FEBRUARY 8 1978

Dockets Nos. 50-277  
and 50-278

The Commission has issued the enclosed Amendments Nos. 39 and 39 to Facility Operating Licenses Nos. DPR-44 and DPR-56 for the Peach Bottom Atomic Power Station, Units Nos. 2 and 3. The amendments revise the Technical Specifications and consist of: (1) addition of interim specifications on fire protection and (2) deletion of the respiratory protection program in accordance with the revocation provision of the current Technical Specifications. The implementation of fire protection specifications is in response to your applications dated February 2, 1977 and July 18, 1977.

PEACH BOTTOM ATOMIC POWER STATION, UNIT NO. 2

PHILADELPHIA ELECTRIC COMPANY PEACH BOTTOM ATOMIC POWER STATION UNITS 2 and 3
MANAGEMENT ORGANIZATION CHART
FIGURE 6.2-1

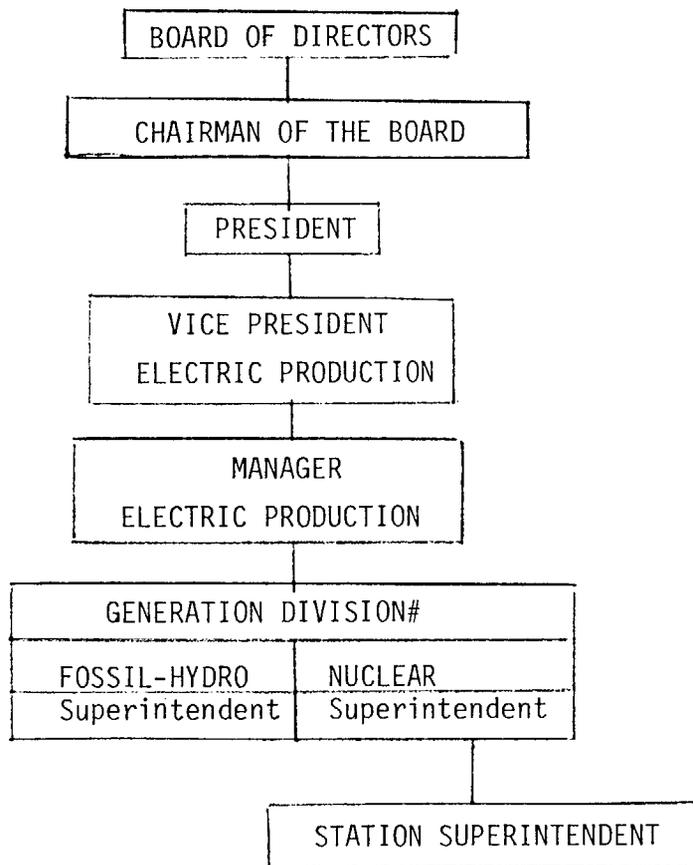
6. Figure 6.2-2. The footnote to this figure has been revised to reflect the Station Superintendent's responsibility for implementation of "on-site fire protection activities." A revised Figure 6.2-1 has been included to reflect the responsibility for implementation of the Over-all Fire Protection Program at the Corporate level.

# - Responsible for overall Fire Protection Program
